PLANS AND DOCUMENTS
referred to in the PDA APPROVAL
14 AUG 2015
MEDQ

AMENDED IN RED

13 AUG 2015
By: Tom Barker (name)
MEDQ

**CONCEPT DESIGN
PROPOSED ROADWORKS
BRUNSWICK ST– FORTITUDE VALLEY**

roof
1:400

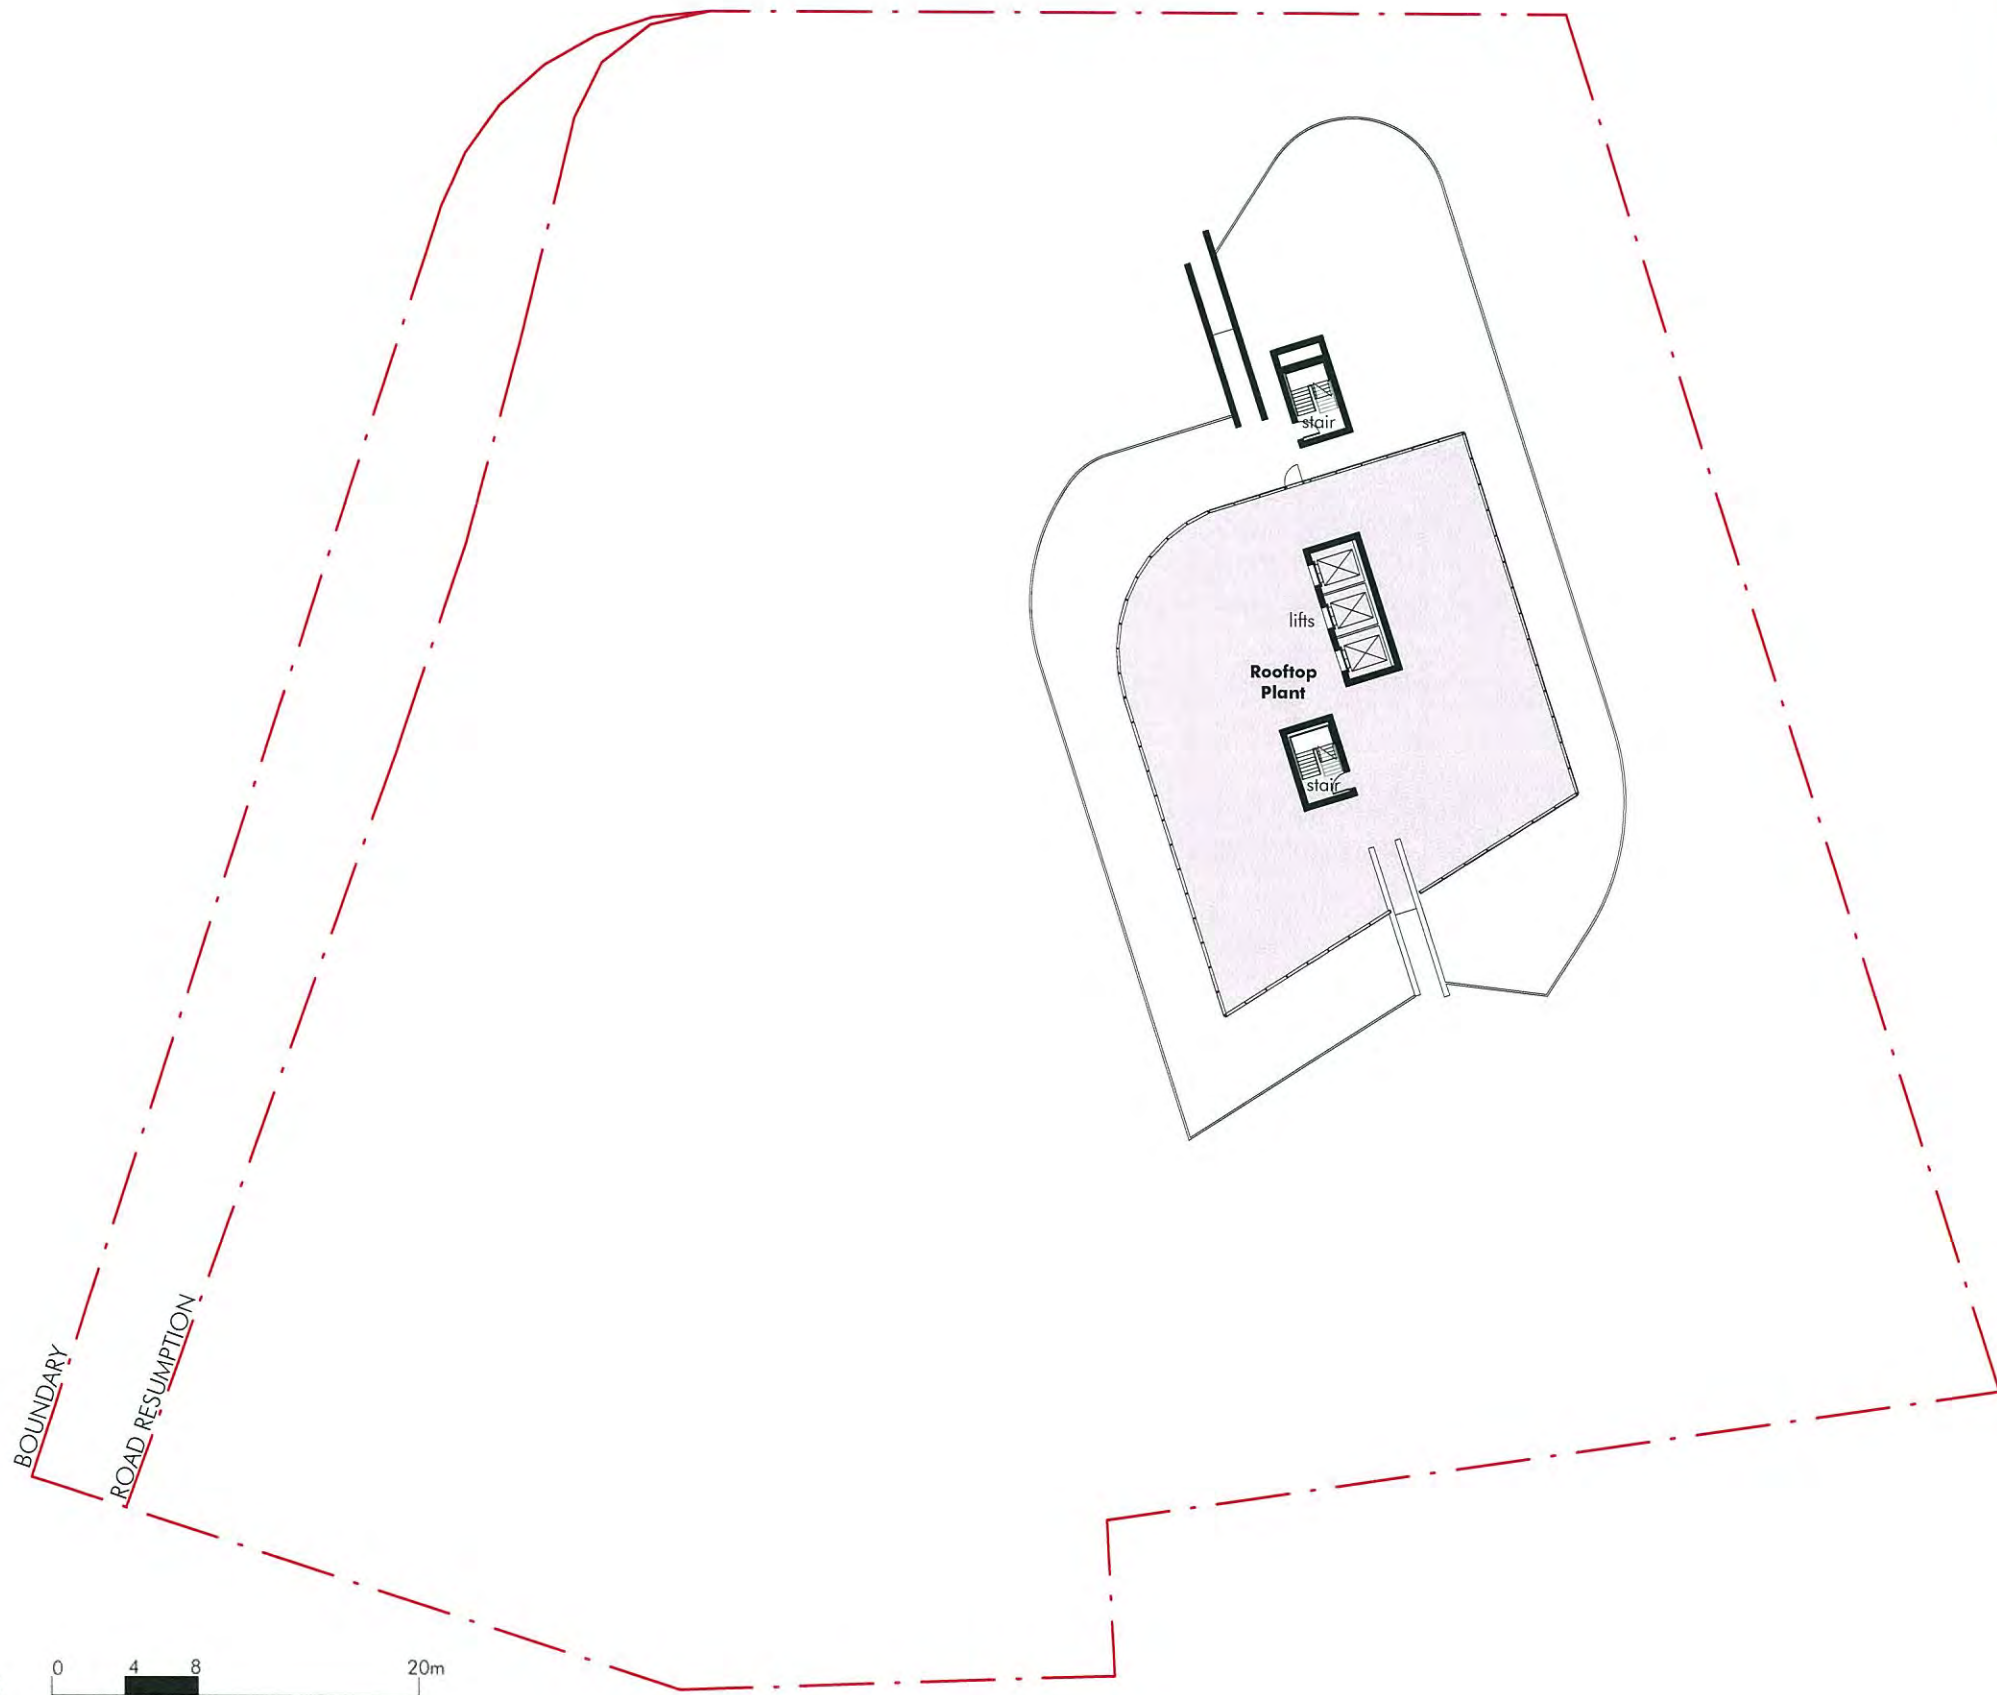
Detailed drawings of roof screening, as required for Compliance Assessment, are to illustrate lift overrun. Not currently illustrated.

overall section

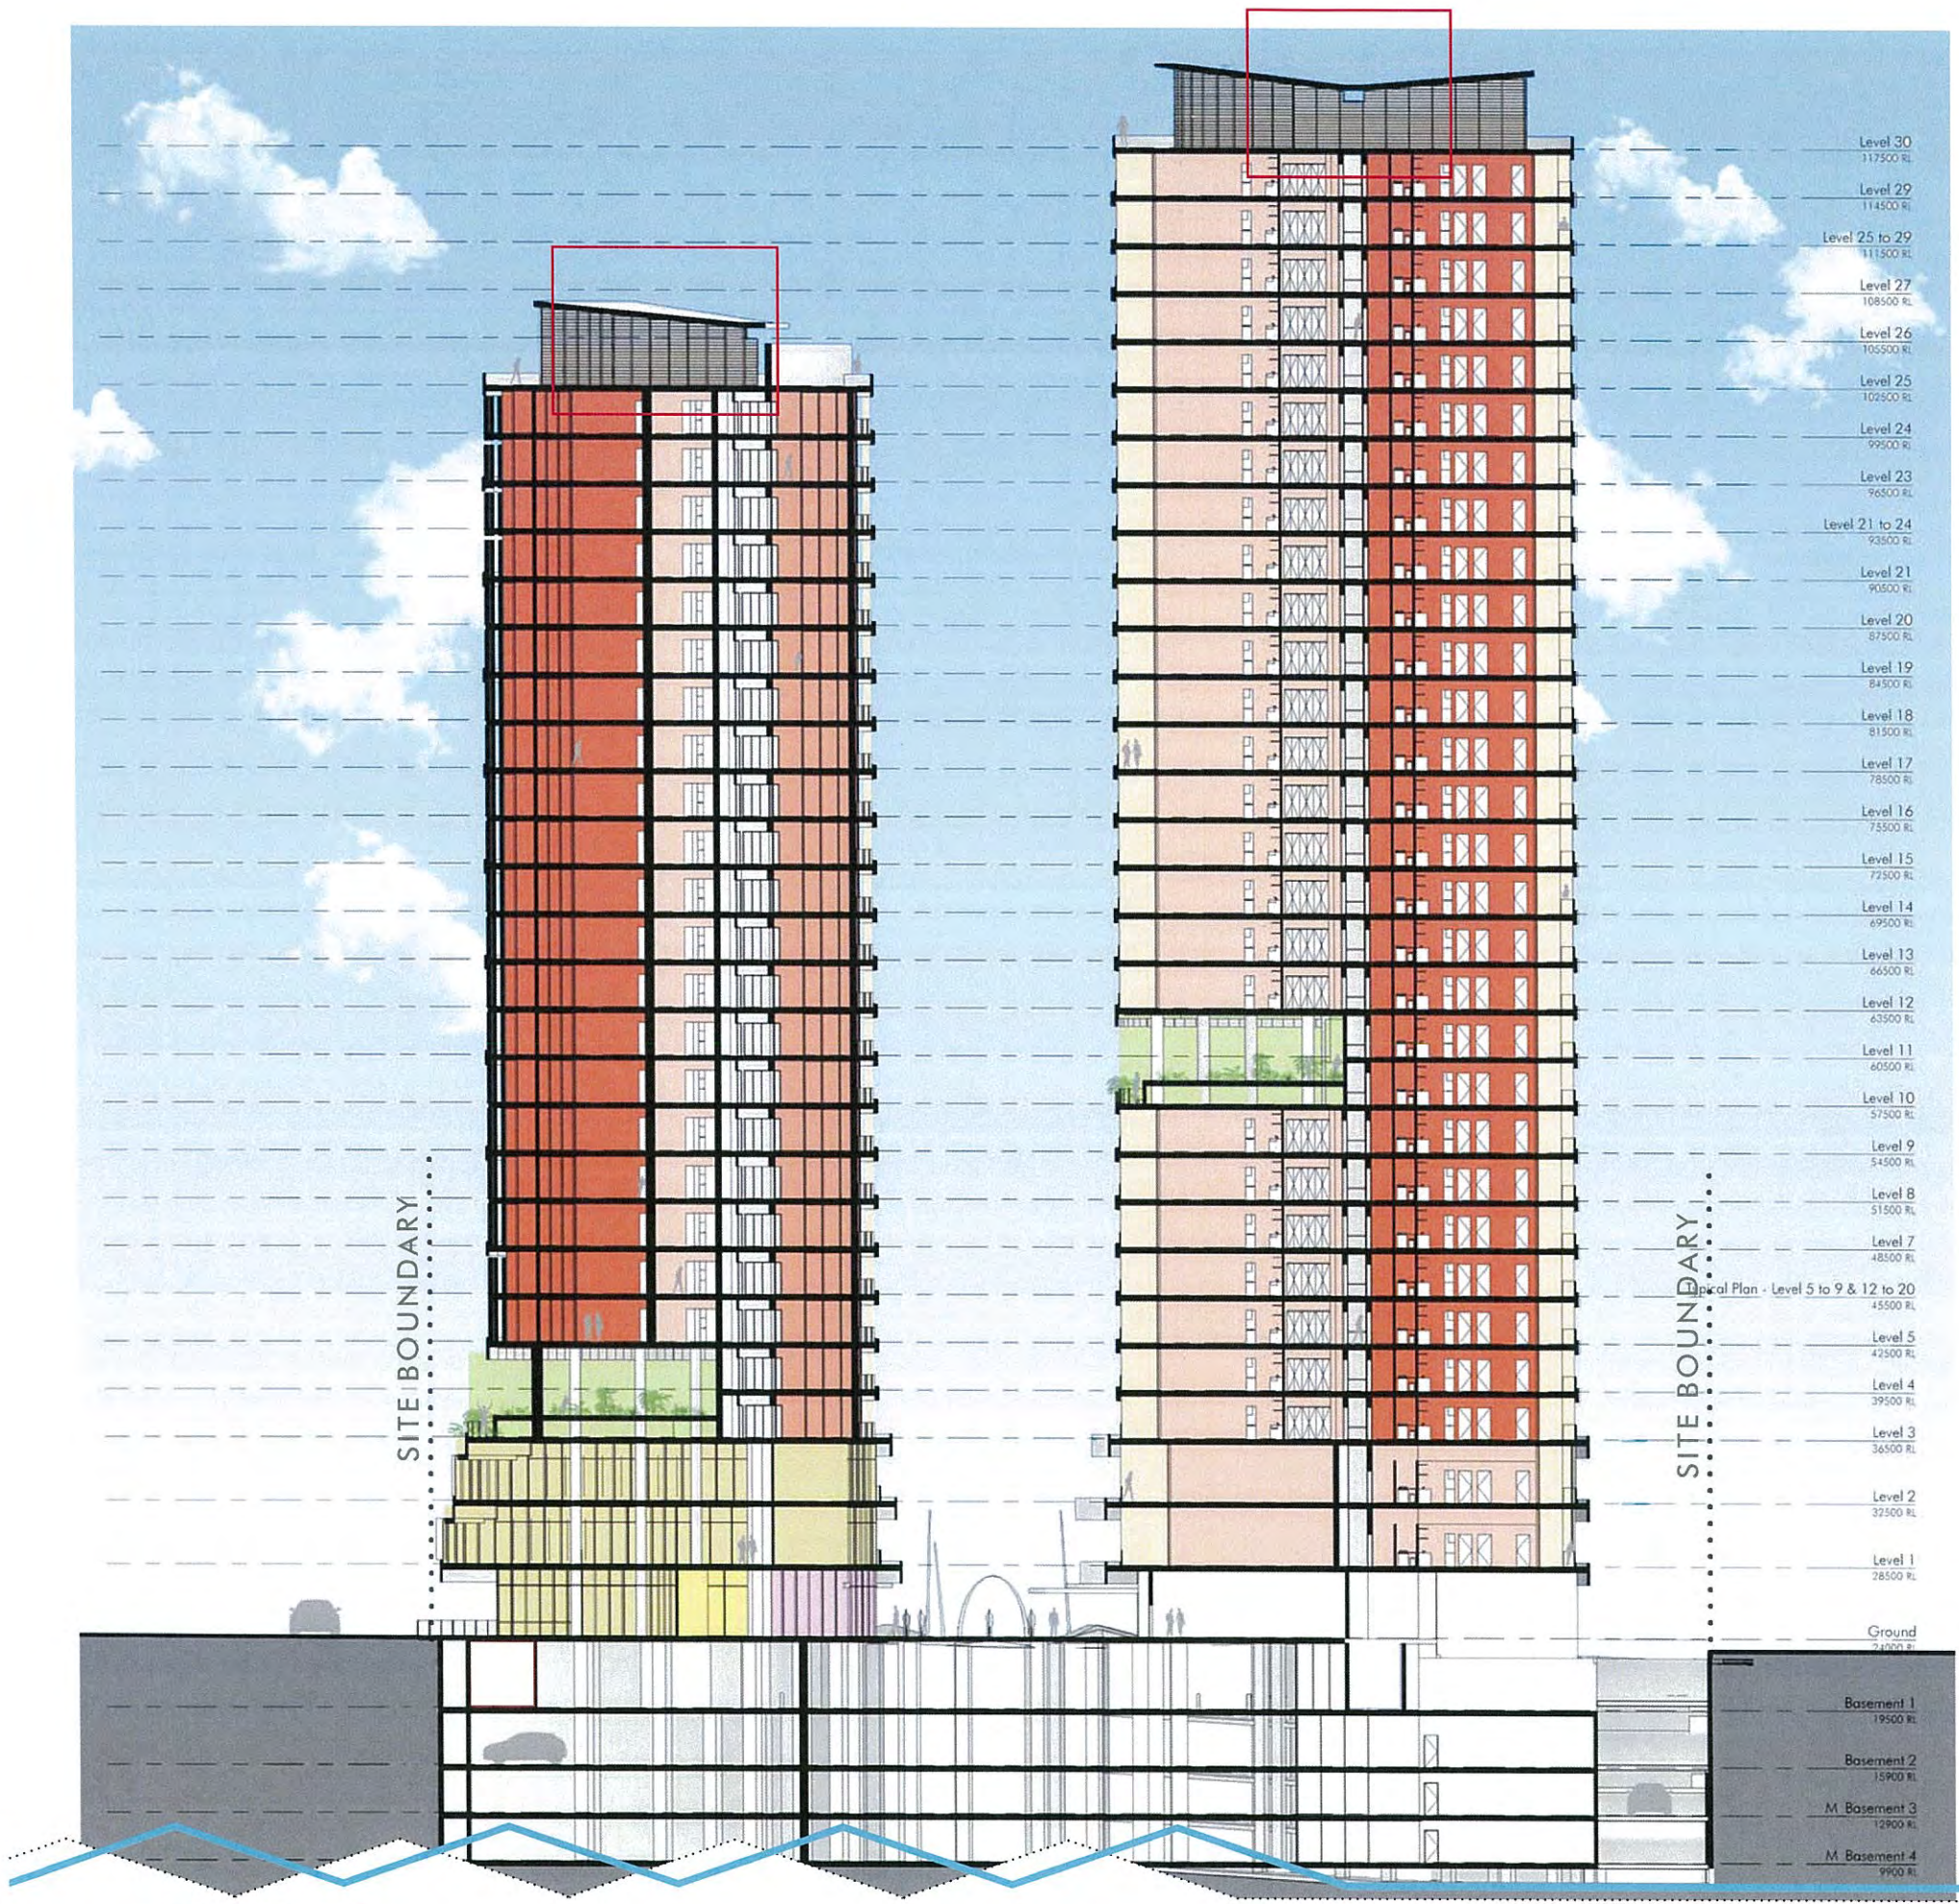
Overall Section does not illustrate Lift Overrun.
See Elevations for this detail.
